SUBJECT: FORWARDS RESPONSES TO NRC 790116 LTR REQUESTING ADDL INFO
 RE RADWASTE REDUCTION SYS (RWR-1).

Re: Niagara Mohawk Power Corporation
Nine Mile Point Nuclear Station Unit 1
Docket No. 50-220
DPR-63

RADWASTE REDUCTION SYSTEM

Additional Information

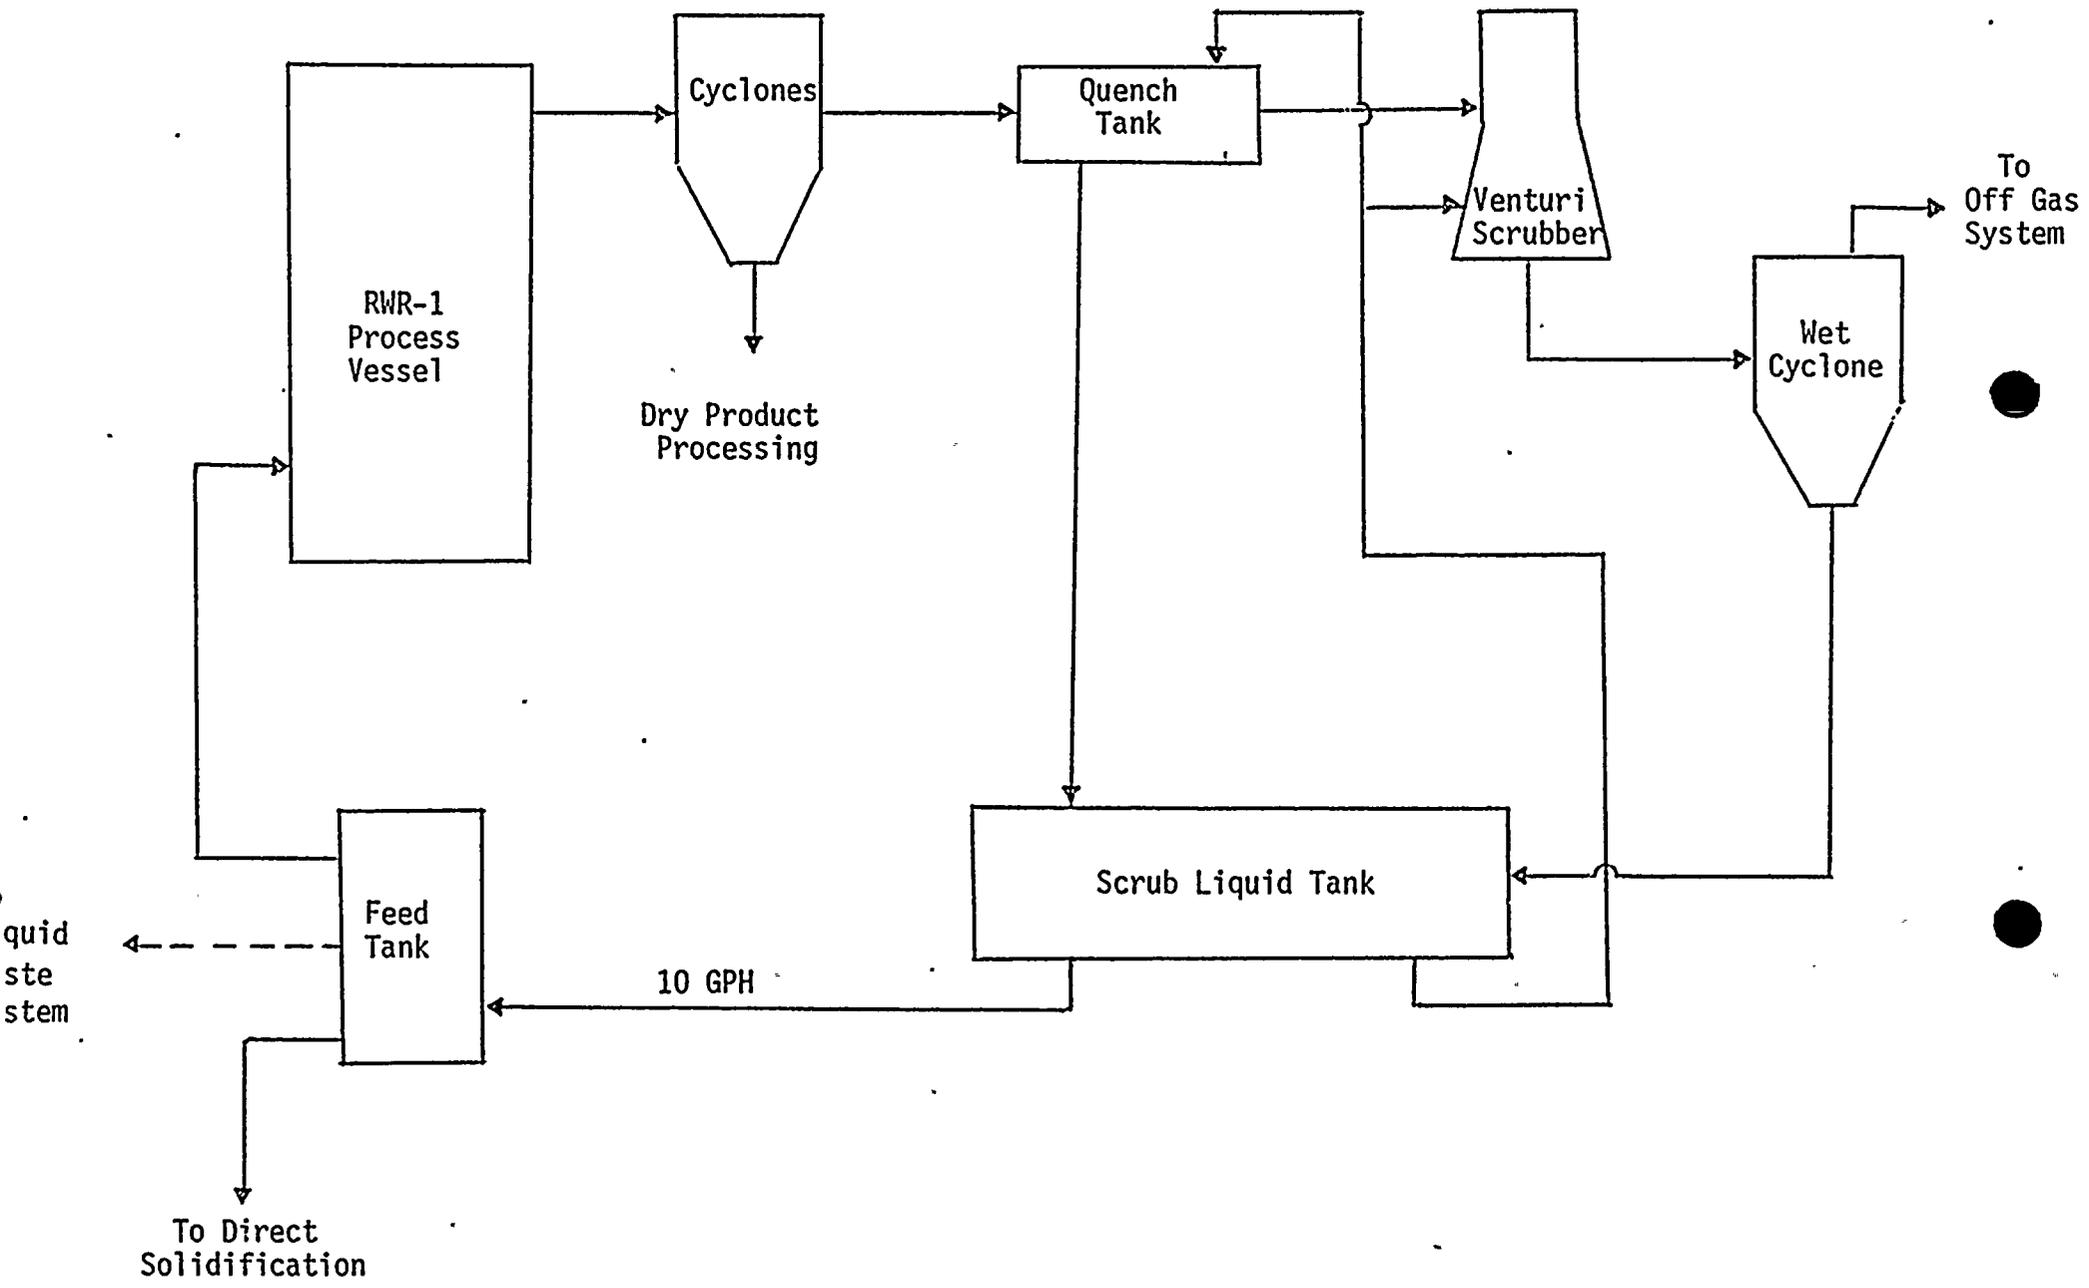
Provide an estimate of the annual volume and radionuclide distribution of the scrub liquid which is to be recycled to the liquid waste system. Describe the processing which the scrub liquid will undergo, including all alternative methods of handling, and provide justification that the liquid waste system has the capability of handling the waste volumes anticipated. Provide a flow schematic of all pathways for disposition of scrub liquid. Indicate the size of the day tank incorporated to feed the radwaste reduction system.

There will be no scrub liquid recycled to the liquid waste system on a normal basis. The scrub liquid will be discharged from the scrub liquid tank to a 2000 gallon feed tank. Flow, as shown by the attached schematic, will be a maximum of 10 gallons per hour. The liquid will have three possible pathways from the feed tank.

The normal pathway is to recycle the liquid back through the RWR-1. A backup pathway is to direct solidification.

Another alternative to be used on an emergency basis is to recycle back to the liquid waste system. This will be used, for example, in the event that the RWR-1 is not operating and maintenance in the area of the feed tank is to be performed. It is projected that this may occur on a maximum frequency of once per year. Consequently, the volume that would be recycled under these conditions would be 2000 gallons or one feed tank capacity.

The liquid waste system has the capacity to handle this volume. This liquid could be diverted to a 25,000 gallon capacity waste neutralizer tank or either of two concentrator bottoms tanks (8,000 and 12,000 gal. in capacity).

Assuming the same activity and composition as that delineated for the accident condition, the total activity in the scrub liquid would be 230 Ci in the tank volume. Since this activity was derived from processing resins in the RWR, the nuclide distribution would be the same as that indicated in Response 1.
